HIGHWAY WORK PROPOSAL

<u>COUNTY</u>	<u>STATE PROJECT</u>	<u>FEDERAL</u>	<u>PROJECT DESCRIPTION</u>	<u>HIGHWAY</u>
Rock	3614-00-75	N/A	Creek Rd, T Of Bradford; Wsor Bridge & Approaches B530177	LOC STR

ADDENDUM REQUIRED ATTACHED AT BACK

Addendum No. 01 ID 3614-00-75 Revised Sheet 94 February 24, 2020

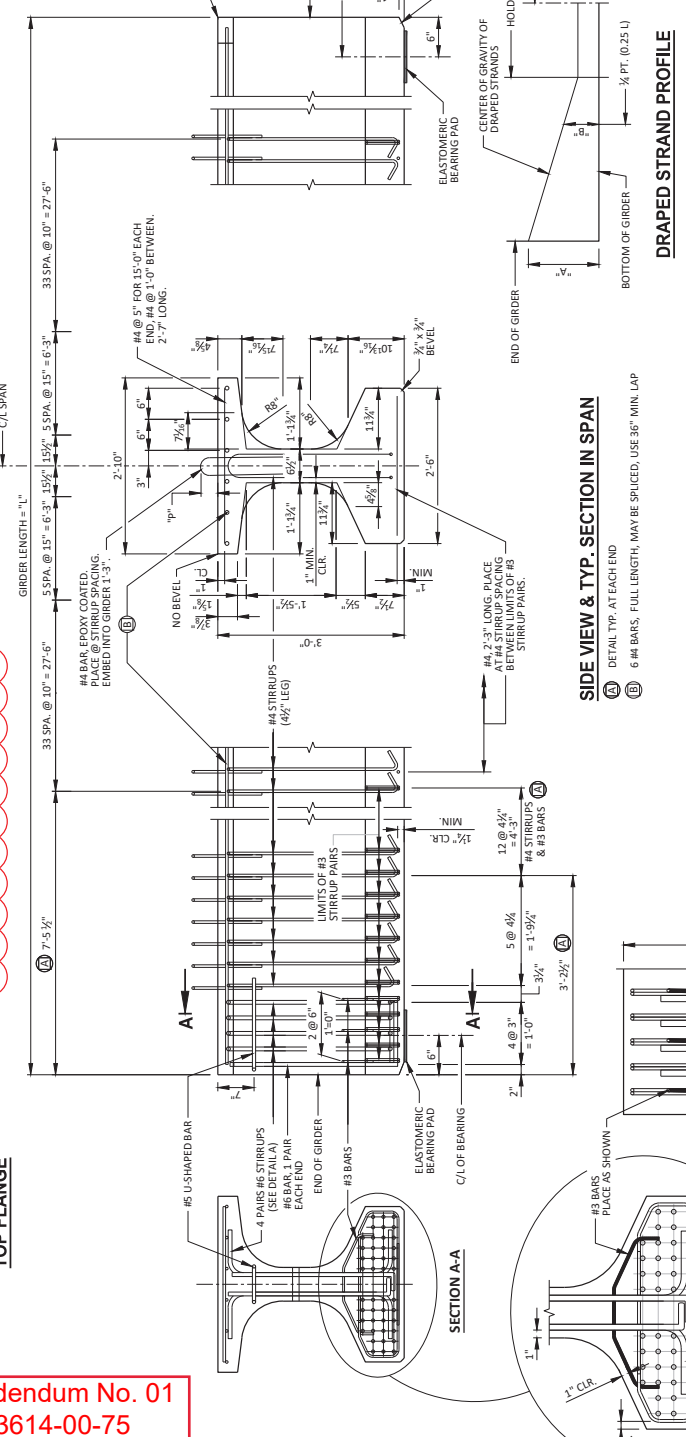
TOP FLANGE TO BE FORMED OUT TO MEET CLEARANCE REQUIREMENTS. SEE DETAILS ON SHEET 8 FOR LOCATIONS AND DIMENSIONS. FOR DIAPHRAGM INSERT & CONNECTION DETAILS SEE "STEEL DIAPHRAGM" SHEET. SEE SHEET 8 FOR LOCATIONS AND THE GIRDERS.

THE THEORETICAL INITIAL CAMBER VALUE AT THE MIDSPAN AND RELEASE AT MIDSPAN

THESE VALUES ARE TO BE USED IN DETERMINING THE BEHAVIOR OF THE GIRDER UNDER LOAD. THESE VALUES ARE FOR INFORMATIONAL PURPOSES ONLY.

Addendum No. 01
ID 3614-00-75
Revised Sheet 100
February 24, 2020

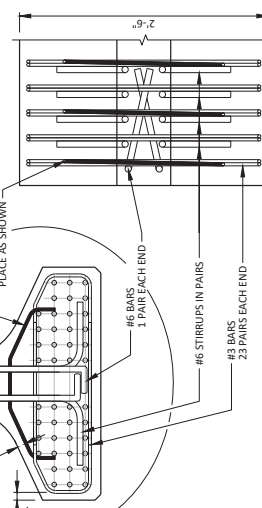
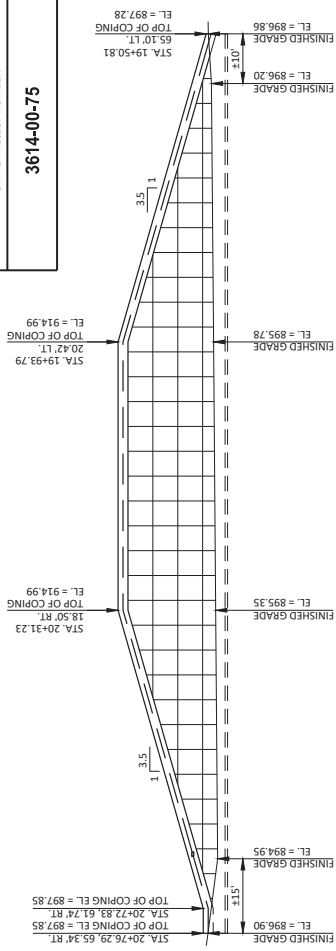
ELEVATION R-53-84
(LOOKING SOUTHWEST AT FRONT FACE OF WALL)

SOIL PARAMETERS

Addendum No. 01
ID 3614-00-75
Revised Sheet 105
February 24, 2020

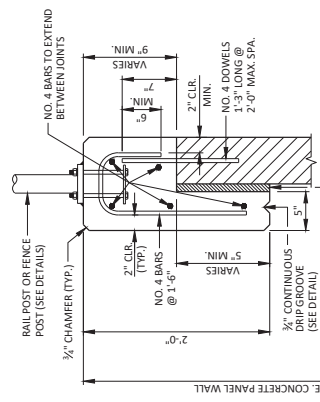
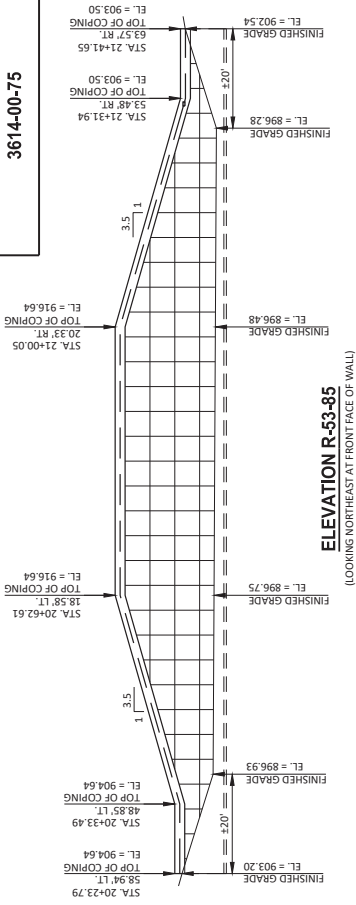
COPING EXPANSION JOINT
DO NOT RUN BAR STEEL THROUGH JOINT.
MAX. SPACING OF JOINT = 5'-0"

NOTES:
DIMENSIONS ARE APPROXIMATE. THE GRATE IS SIZED TO FIT INTO A PIPE COUPLING.
ORIENT SHIELD SO SLOTS ARE VERTICAL
THE RODENT SCREEN, PIPE COUPLING AND SCREWS SHALL BE IDENTICAL TO THE BID ITEM "PIPE UNDERDRAIN WRAPPED 6-INCH".
THIS SCREEN SHALL BE FASTENED TO THE PIPE UNDERDRAIN WITH TWO OR MORE NO. 10X 1/2 INCH STAINLESS STEEL SHEET METAL SCREWS.

ELEVATION R-53-85
(LOOKING NORTHEAST AT FRONT FACE OF WALL)

SAFETY FACTORS FOR MSE WALLS

ALL SAFETY FACTORS ARE CALCULATED FOR THE WALL HEIGHTS AND REINFORCEMENT LENGTHS SHOWN IN THE TABLE. SEE GEOTECHNICAL REPORT FOR FURTHER INFORMATION. FINAL DESIGN FOR INTERNAL AND EXTERNAL STABILITY IS THE RESPONSIBILITY OF THE WALL DESIGNER AND MAY BE DIFFERENT FROM THE VALUES IN THE TABLE. SOIL REINFORCEMENT MUST EXTEND A MINIMUM OF 3.0' BEYOND THE FAILURE PLANE FOR INTERNAL STABILITY AS DEFINED BY AASHTO SPECIFICATIONS.
